Planning Commission Staff Report

March 14, 2012
Item 6.a.

- SUBJECT:** PUD-85-08-12D (Site 1), PUD-81-30-86D (Site 2), & P11-0856
- APPLICANT:** Bob Linder / BRE Properties, INC.
- PROPERTY OWNERS:** WP Carey (Site 1) and BRE Properties Inc. (Site 2)

Figure 2: Site 1

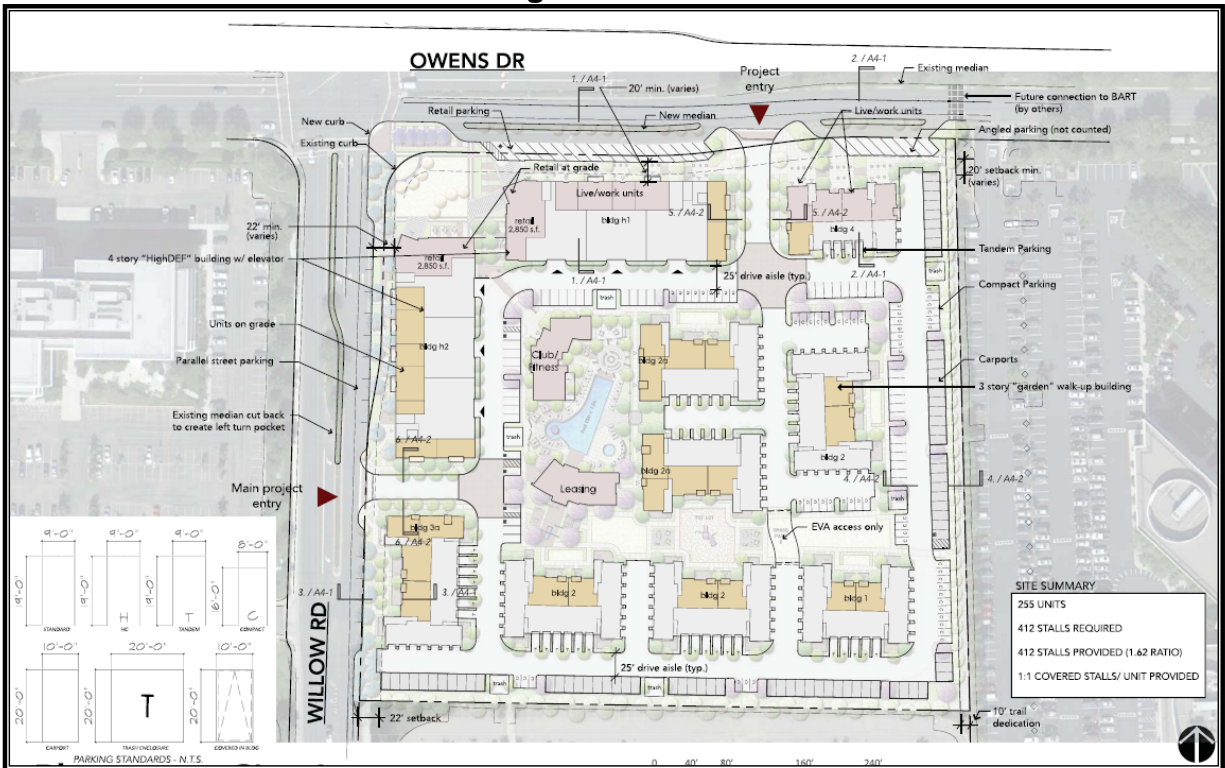
2. The median strip that separates Owens Drive from the diagonal parking should incorporate shrubs for screening. The guidelines require parking to be screened by low walls and landscaping.

Comments: The landscaping plans have not been revised to reflect the installation of shrubs; however, the applicant is not requesting an exception and has indicated that this requirement will be met. Staff has added a condition of approval to reflect this requirement (Exhibit A-1, No. 6).

4. The live/work units on Site 1 do not meet the minimum storefront depth of 40-feet. Furthermore, as proposed, it does not appear that the live/work units could later be converted to retail or service uses given the proposed depth.

Comments: The proposed plans indicate a 30-foot depth for the retail, live/work buildings on Site 1 and 2; however, the applicant has since provided alternative retail depth plans for Site 1 and 2 for the Commission's consideration (please refer to Exhibit F).

As shown in the alternative plans for Site 1, the retail, live/work building (building "A"), located on the west side of the project entry, could have a 40-foot depth if the City would support moving the building 4-feet south, thereby eliminating the landscaping at the rear of the garage entrances, and extending the building 6-feet to the north (towards Owens Drive), which would provide 8-foot deep internal storage areas at the rear of the spaces, but would reduce the front (Owens Drive) setback from 20-feet to 14-feet. Staff notes that the minimum setback is 20-feet; 14-feet of pedestrian area and 6-feet of landscaping (page 15 of the TOD guidelines). Relocating the building and increasing the depth would change the appearance of the building; however, the alternative design breaks up the wall massing as there will no longer be a continuous wall line along Owens Drive.

The alternative plan for the retail, live/work building (building "B"), located adjacent to the proposed trail on Site 1, would require extending the building 10-feet north, towards Owens Drive, in order to have a 40-foot depth. Extending the building towards Owens Drive would reduce the front setback on Owens Drive from 35-feet to 31-feet. The alternative proposal would also allow the applicant to extend the patio covers of the

live/work units on the upper floor. Similar to the other retail, live/work building on Site 1, the change would alter the appearance of the building along Owens Drive; however, instead of having a “break” in the wall, the front façade would have a continuous wall.

Staff is of the opinion that the reduction in front setback for building “A” and “B” is not appropriate in order to meet the 40-foot retail, live/work depth requirement. Staff believes that reducing the setback to 16-feet, versus the required 20-feet, and providing a retail, live/work depth of 38-feet is more appropriate for Site 1. Staff would also recommend a 38-foot retail, live/work depth for Site 2 and could support reducing the setback as proposed since it is not as a significant of a reduction as Site 1 (i.e. 3-foot reduction versus a 6-foot reduction). Therefore, an exception to the TOD Standards and Guidelines would be required in order to reduce the setback to 16-feet for Site 1 and 30-feet for Site 2 and to reduce the depth of the retail, live/work units on both sites to 38-feet.

Figure 3: Site 2

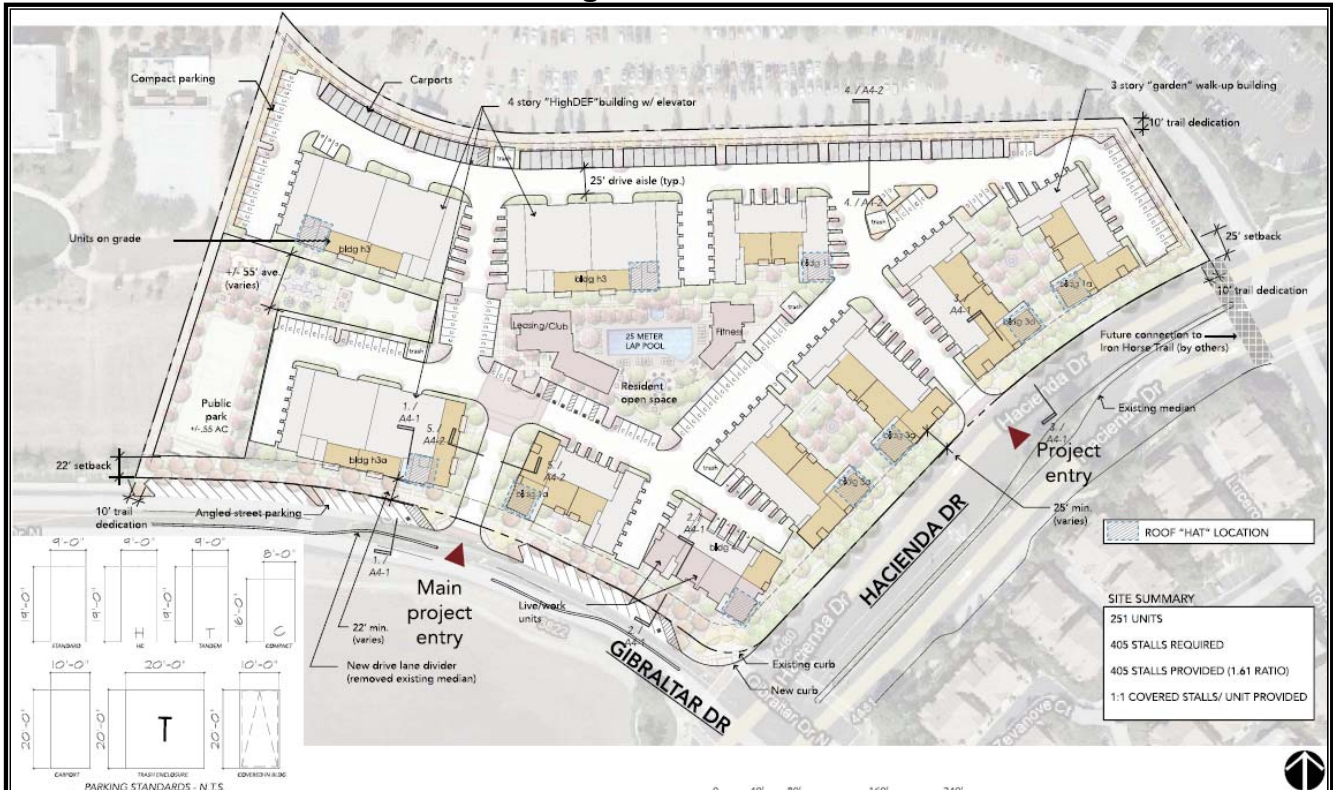
3. The live/work units for Site 2 do not meet the minimum 50% requirement of building frontage along Gibraltar Drive.

Comments: As proposed, the building frontage on Gibraltar Drive has 28% live/work. The applicant is requesting an exception to this requirement as they feel they are meeting the intent of the Guidelines. During the joint City Council/Planning Commission meeting, the Council expressed their concern with the amount of live/work building frontage that was being provided.

The retail, live/work building on Site 2 (building “C”), located on the corner of Gibraltar Drive and Hacienda Drive, would require extending the building up to 6-feet towards Gibraltar Drive in order to have a depth of 40-feet. Extending the building towards Gibraltar Drive would reduce the front setback from 32-feet to 30-feet. Staff notes that the minimum setback is 33-feet (page 18 of the TOD guidelines). Similar to building “B” on Site 1, the alternative proposal would allow the applicant to extend the patio covers of the live/work units on the upper floor. The alternative plan would alter the appearance of the building; instead of having a “break” in the wall, the front façade would have a continuous wall.
